Our ref: TA 165 181
Your ref: PA/2023/422 / PA/2023/421

National Highways has reviewed memorandum [memo] entitled 'National Highways Response 1' [16th February 2024] and we offer the following comments.

Prepared for: Simon Geoghegan
Prepared by: Joshua Bell
Date: 7th March 2024
Case Reference: DevHU0163
Document Reference: DevHU0163 003 TM
Reviewed/approved by: Terry Dale

This Technical Memorandum [TM003] will set out the JSJV review of the information presented in support of both applications.

Figure 4 – Junction Count Locations⁵

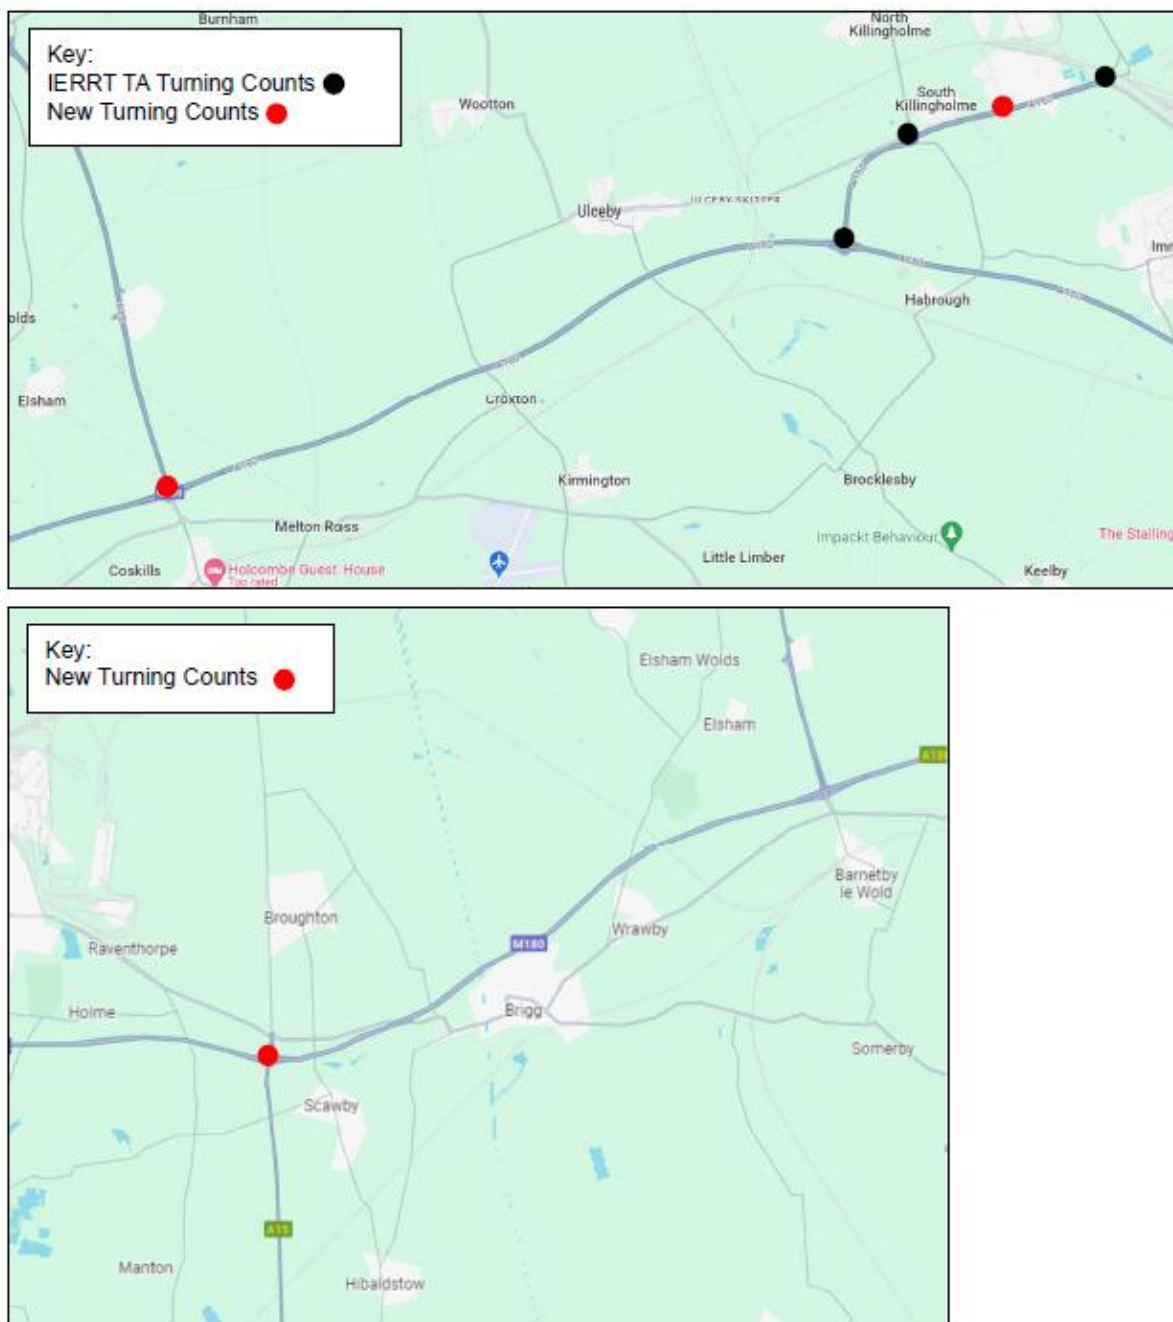
However, new junction turning counts will be carried out at the M180 / A15 junction (M180 J5), M180 J4 and at the A160 Eastfield Road junction, as this data was not available from other sources. These will take place during late February outside of the school half term holidays.”

JSJV notes that paragraph 3.3.7 of TAG Unit M1.2 [May 2020] states that:

“Neutral periods are defined as Mondays to Thursdays from March through to November (excluding August), provided adequate lighting is available, and avoiding the weeks before/after Easter, the Thursday before and all of the week of a bank holiday, and the school holidays. Surveys may be carried out outside of these days/months, ensuring that the conditions being surveyed (e.g., traffic flow) are representative of the transport condition being analysed/modelled.”

Therefore, JSJV considers it appropriate that the traffic survey flows presented in any forthcoming documentation are supported by an analysis to demonstrate that the flows are representative. Nonetheless, the survey locations are shown in **Figure 5** for reference.
